CONTAINMENT SYSTEMS3/4.6.3 CONTAINMENT ISOLATION VALVESLIMITING CONDITION FOR OPERATION

ATTACHMENT 3

Insert to TS 3/4.6.3 (** footnote)

CALLAWAY PLANT - FAULT TREE MODEL OF PENETRATION P-76

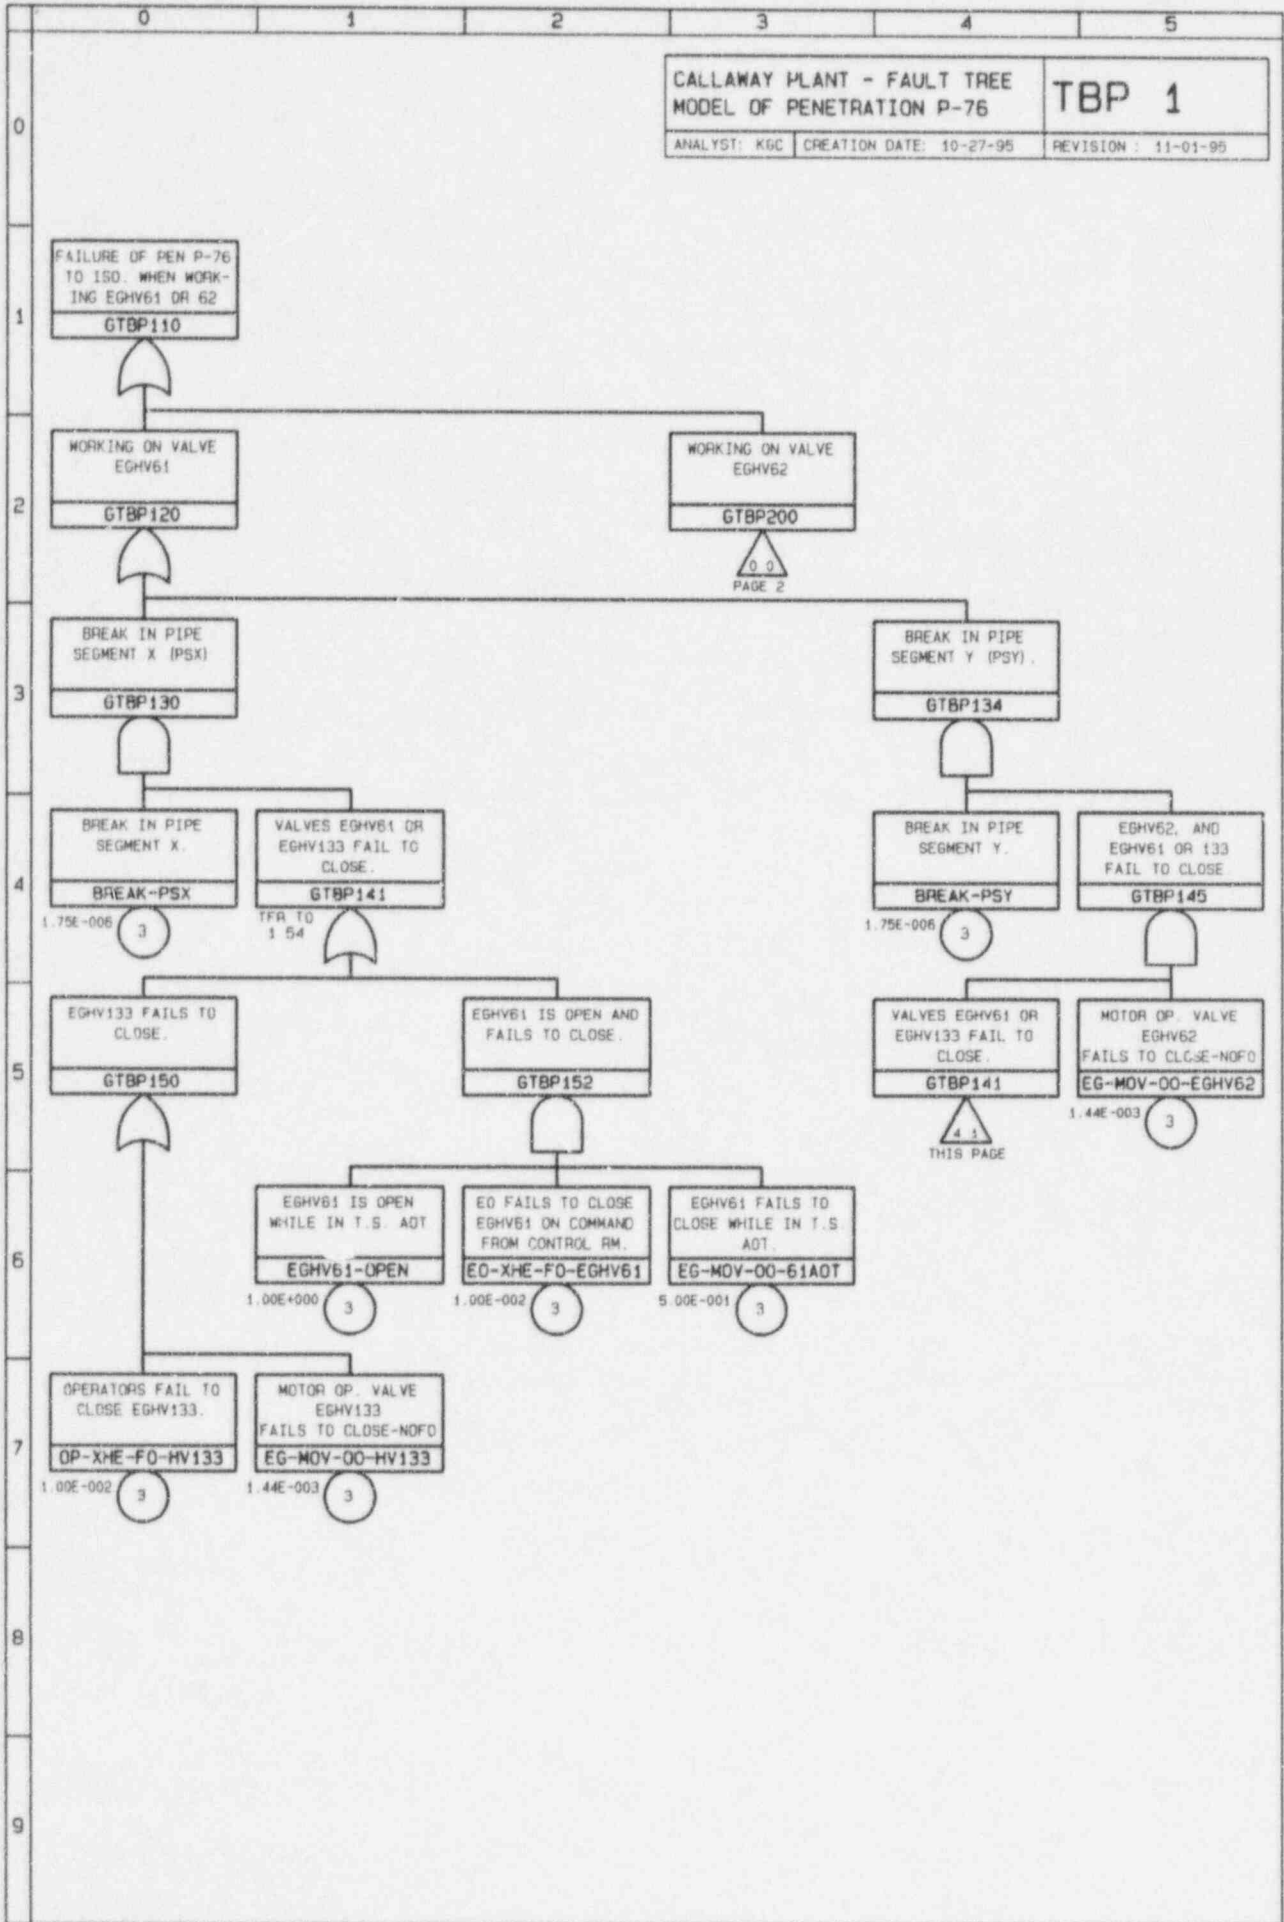
3.6.3 ^{Each} ~~The~~ containment isolation valve~~s~~ specified in Table 3.6-1 shall be OPERABLE, with isolation times as shown in Table 3.6-1. *

4.6.3.1 ^{Each} ~~The~~ containment isolation valves specified in Table 3.6-1 shall be demonstrated OPERABLE prior to returning the valve to service after maintenance, repair or replacement work is performed on the valve or its associated actuator, control or power circuit by performance of a cycling test, and verification of isolation time.

** INSERT HERE

For penetrations with parallel containment isolation valves, the penetration is considered isolated if the flowpath with the inoperable valve has been isolated. The penetration may still have flow through it utilizing a parallel flowpath. For the motor operated valves associated with reactor coolant pump cooling, automatic isolation valves (EGHV58, 59, 60, 61, 62) and remote manual isolation bypass valves (EGHV127, 130, 131, 132, 133), 12 hours are allowed to conduct actuator diagnostic evaluations which are required for post maintenance testing to restore a motor operated valve to an OPERABLE condition, during which time, the valve may be energized for short periods of time for the purpose of cycling.

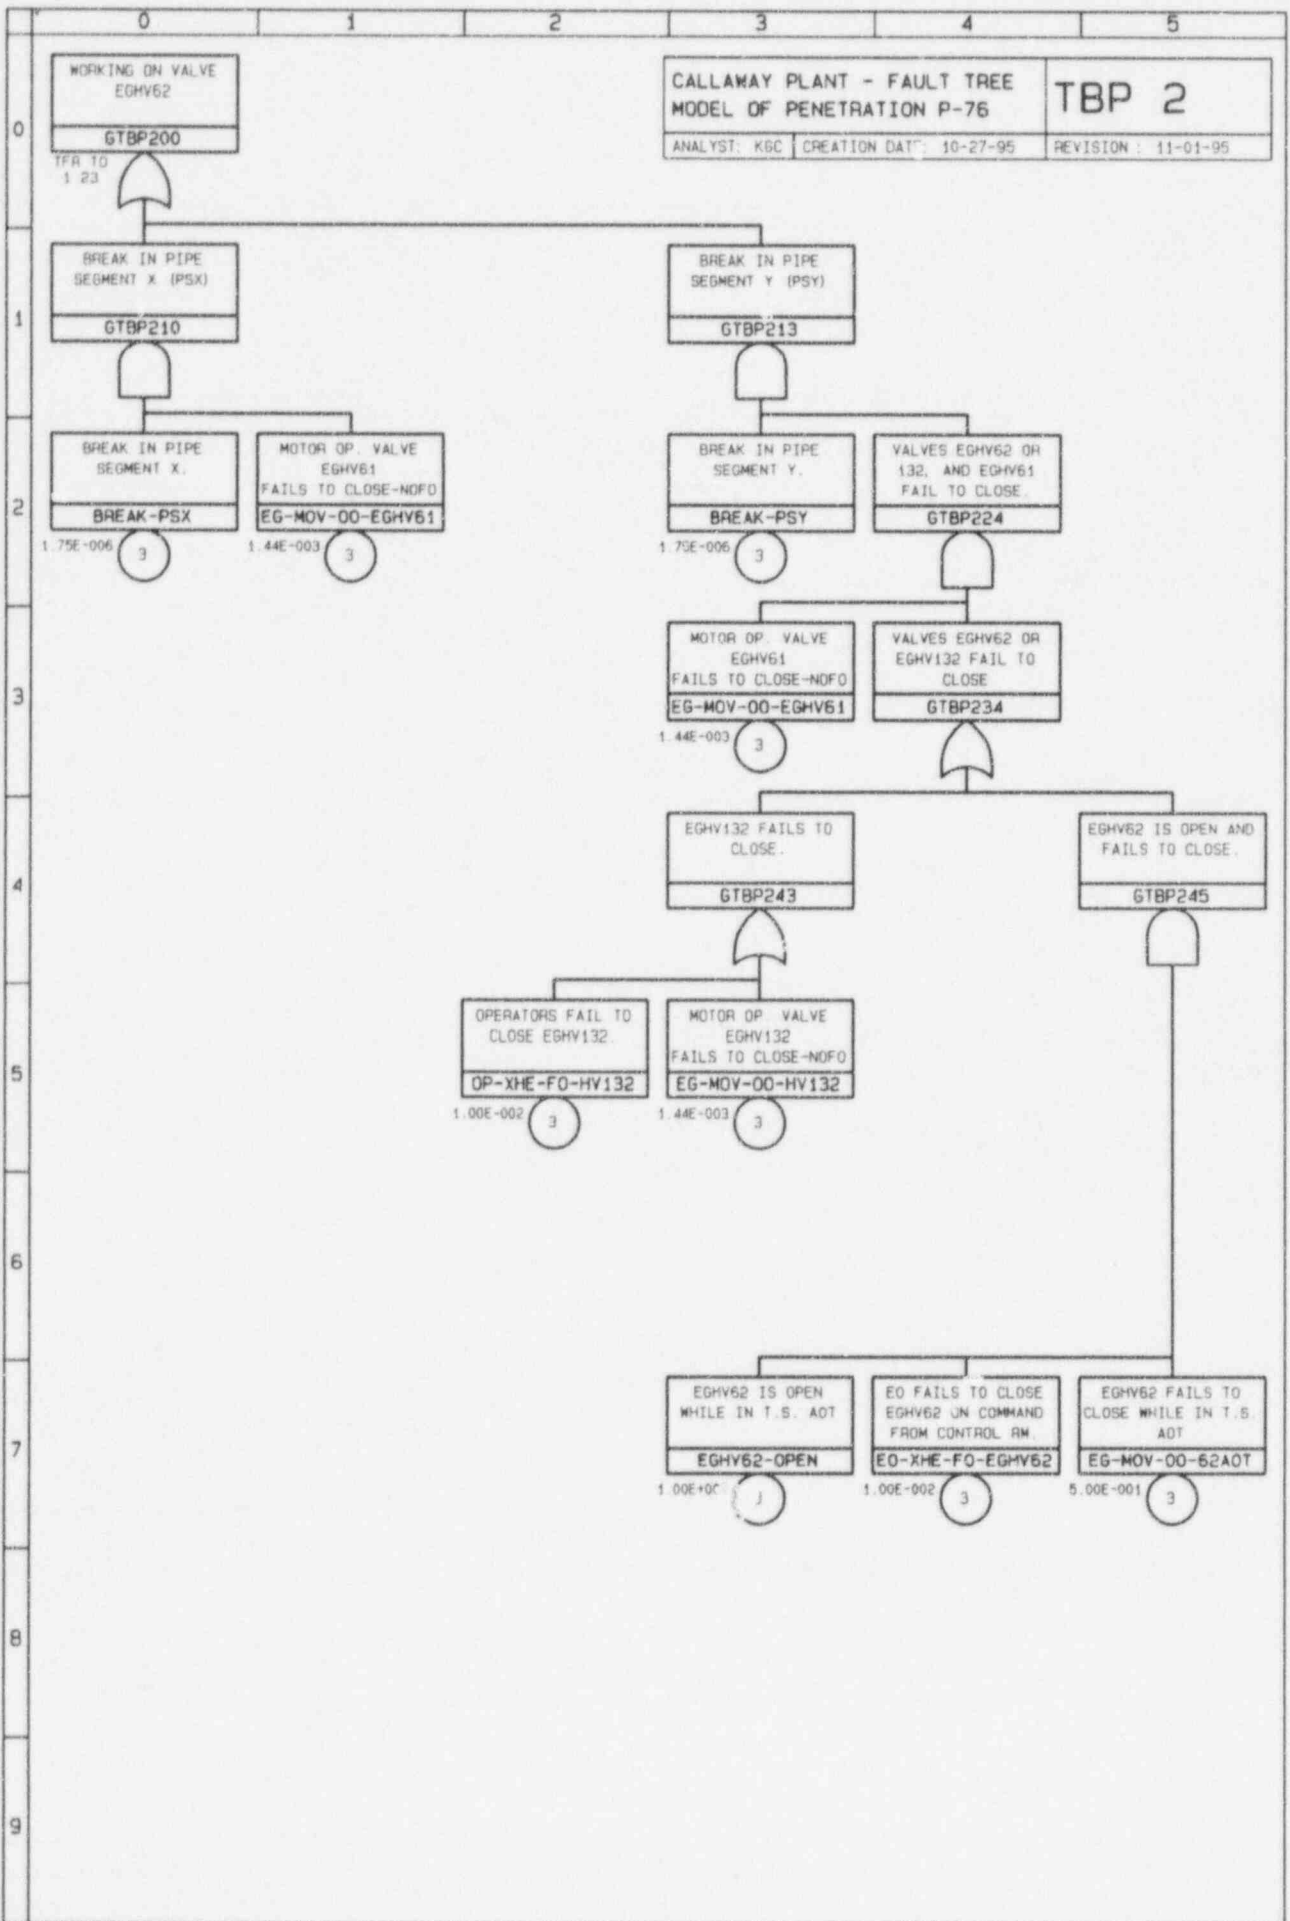
Top event: GTBP110
 Top event unavailability (r.ev. appr)= 3.14E-08
 Cutoff value used = 1.00E-20
 Number of Boolean Indicated Cut Sets = 10
 Number of MCS in equation file = 10

1.	1.75E-08	OP-XHE-FO-HV133	BREAK-PSX	
2.	8.75E-09	BREAK-PSX	EGHV61-OPEN	EO-XHE-FO-EGHV61
		EG-MOV-OO-61AOT		
3.	2.52E-09	BREAK-PSX	EG-MOV-OO-EGHV61	
4.	2.52E-09	EG-MOV-OO-HV133	BREAK-PSX	
5.	2.52E-11	OP-XHE-FO-HV132	EG-MOV-OO-EGHV61	BREAK-PSY
6.	2.52E-11	OP-XHE-FO-HV133	EG-MOV-OO-EGHV62	BREAK-PSY
7.	1.26E-11	BREAK-PSY	EG-MOV-OO-EGHV62	EGHV61-OPEN
		EO-XHE-FO-EGHV61	EG-MOV-OO-61AOT	
8.	1.26E-11	BREAK-PSY	EG-MOV-OO-EGHV61	EGHV62-OPEN
		EO-XHE-FO-EGHV62	EG-MOV-OO-62AOT	
9.	3.63E-12	EG-MOV-OO-HV132	EG-MOV-OO-EGHV61	BREAK-PSY
10.	3.63E-12	EG-MOV-OO-HV133	EG-MOV-OO-EGHV62	BREAK-PSY
